Complaint – Creaking Noise from the Driver's or Passenger Footwell: Reworking Floorpan (98/21)

Model Series: **Taycan (Y1A / Y1B / Y1C)**

Concerns: **Floorpan**

Overview of floorpan (example in right footwell)

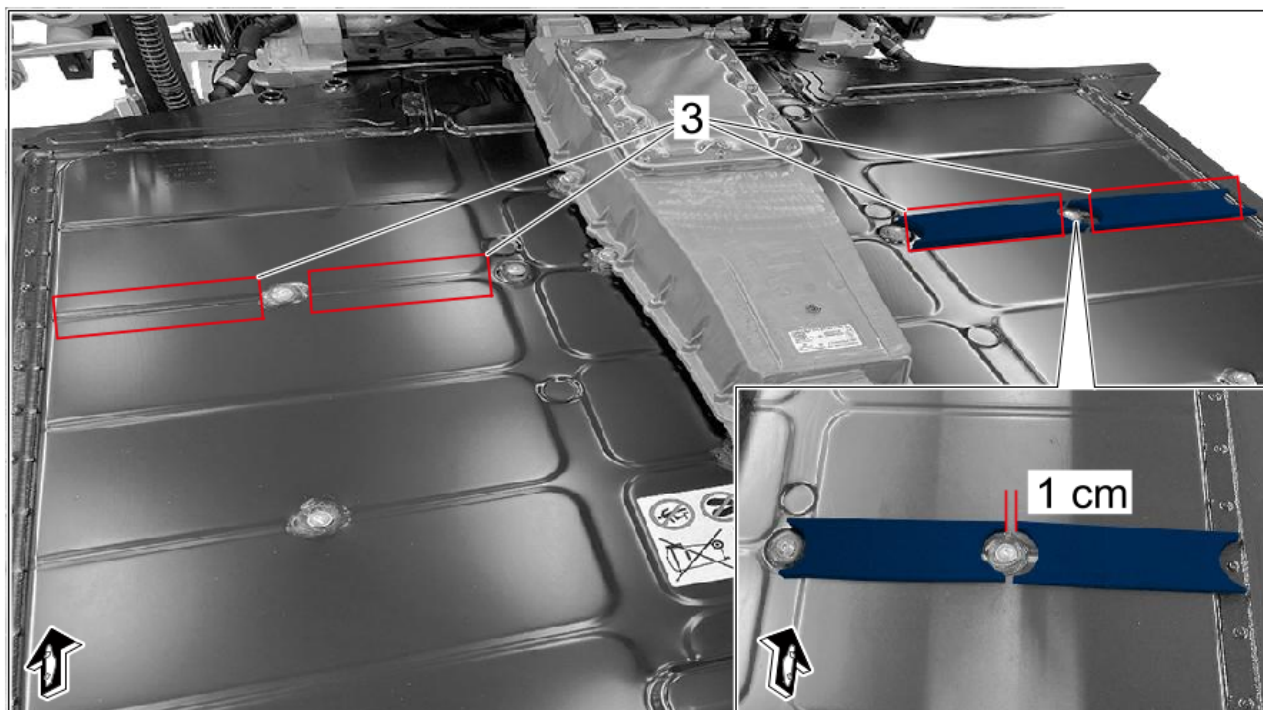
Action required: In the event of a customer complaint, reshape the floor pan on the relevant side in order to increase rigidity.
Also attach 4 plastic foam strips to the high-voltage battery.

- 1 – Re-stamping position 1 (3 places in total)
- 2 – Reshaping position 2 (one place , only if required)

Floorpan position 1

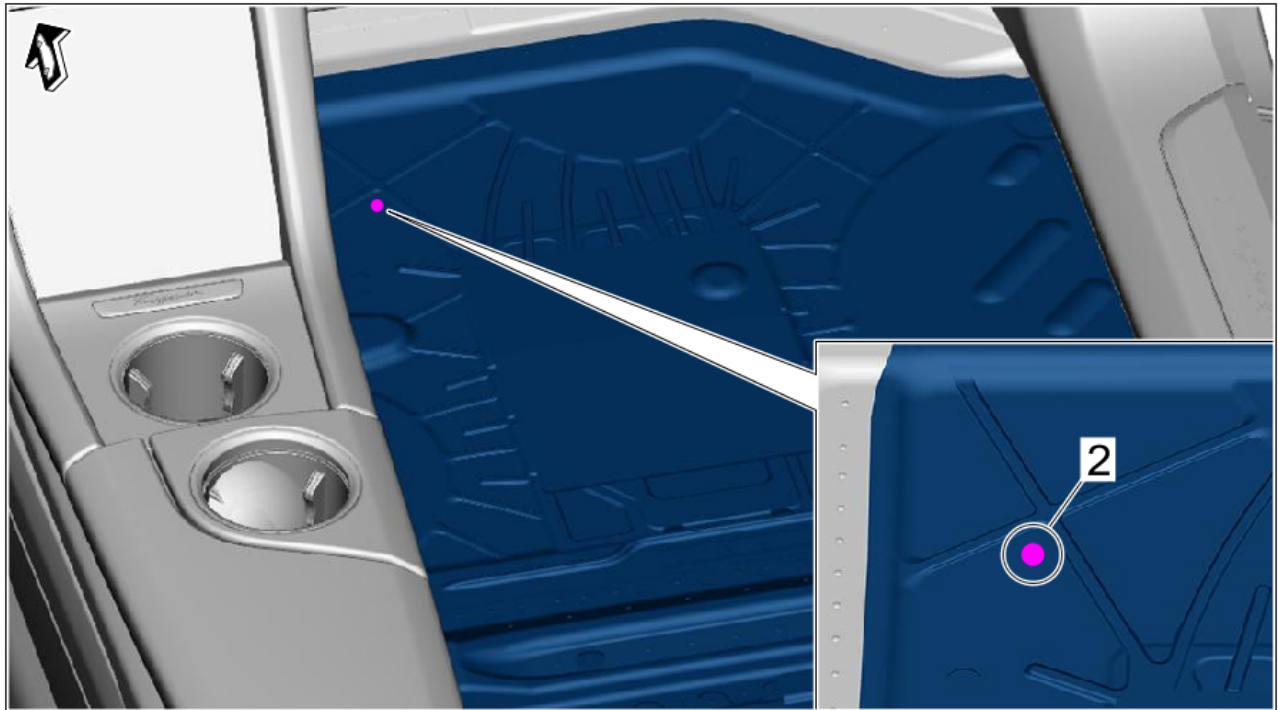
Information: Creaking noise can be heard from the driver's or passenger's footwell when the vehicle floor is loaded and relieved (e.g. when getting in and out of the vehicle). This is caused by the floor pan, which bends downwards and then jumps back to its original position.

- 1 Re-shape the floorpan at position 1 (3 places in total) using a plastic hammer and drift by tapping it with a well-aimed hammer blow and making sure not to damage the coating on the floorpan. ⇒ *Floorpan position 1*

Floorpan position 2

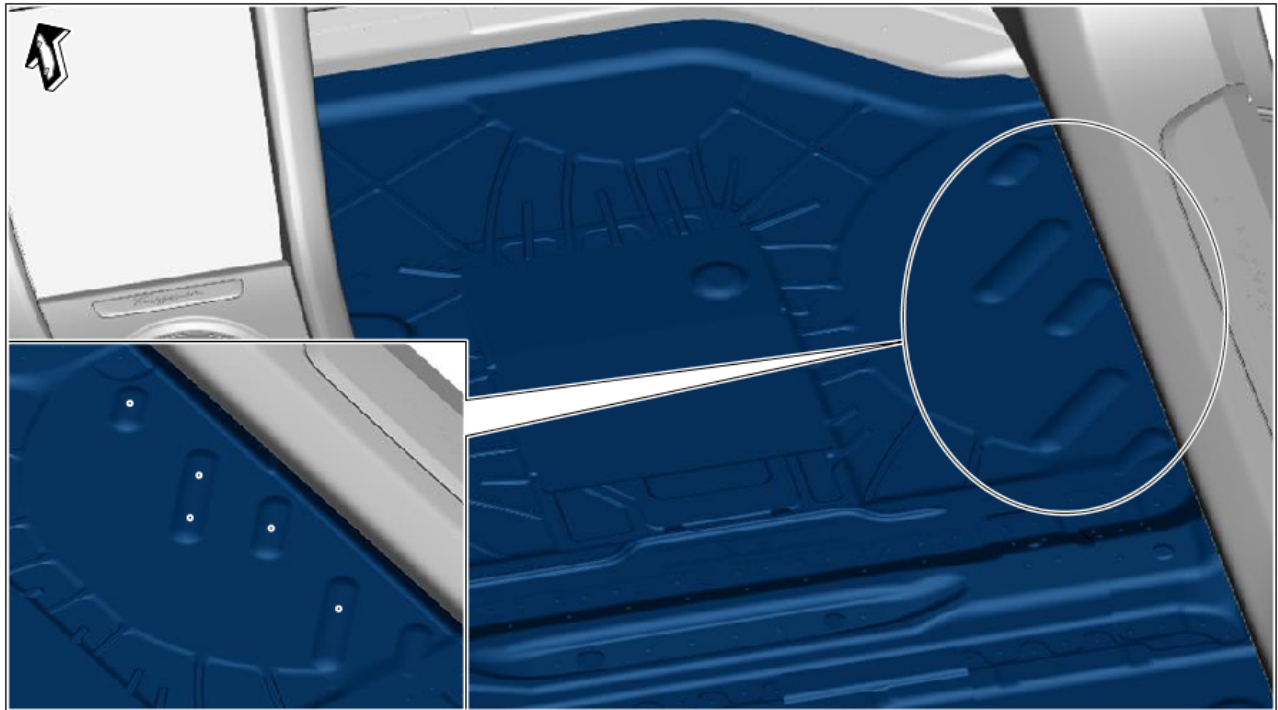
- 2 Check whether there is still a creaking noise on applying pressure and load.
- 3 If the creaking noise is still present, re-shape the floorpan at position 2 using a well-aimed hammer blow and make sure not to damage the coating on the floorpan. ⇒ *Floorpan position 2*

Beading in floorpan

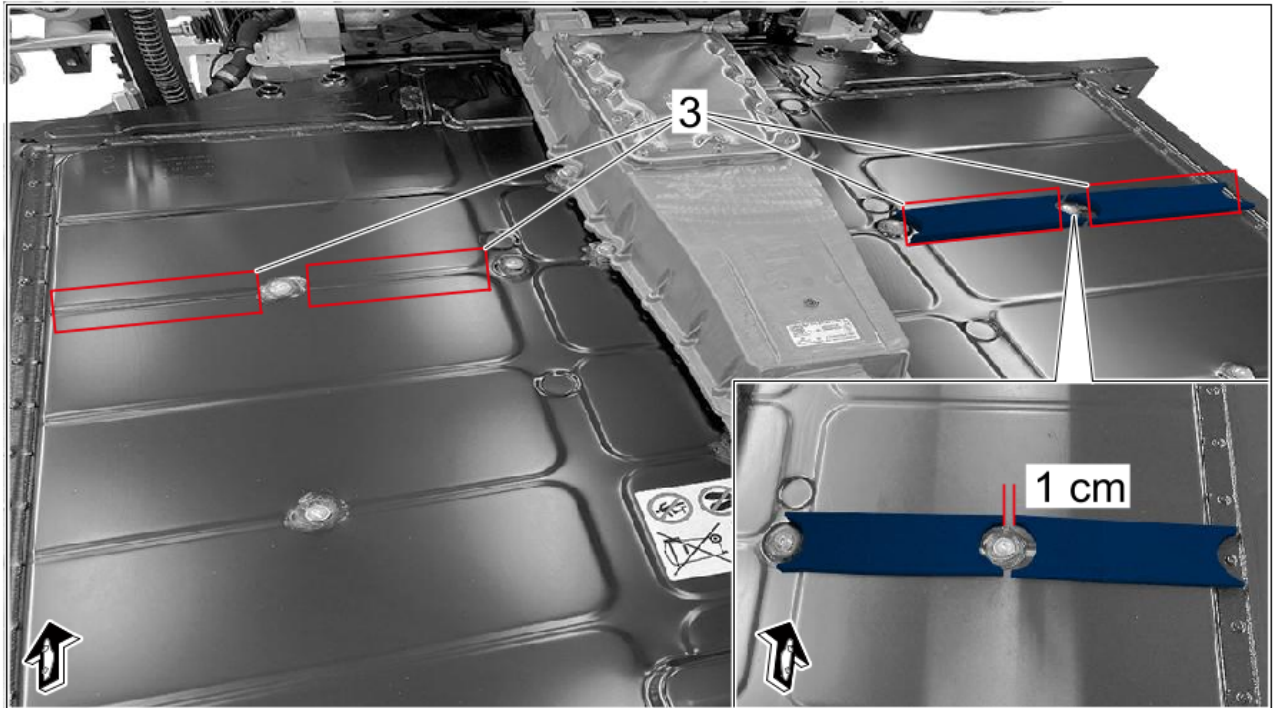
- 4 The creaking noise can continue in some cases. If this is the case, also re-shape the beading in the floorpan at the marked positions (a total of 5 locations) by tapping it directly with a hammer and making sure not to damage the coating on the floorpan. ⇒ *Beading in floorpan*
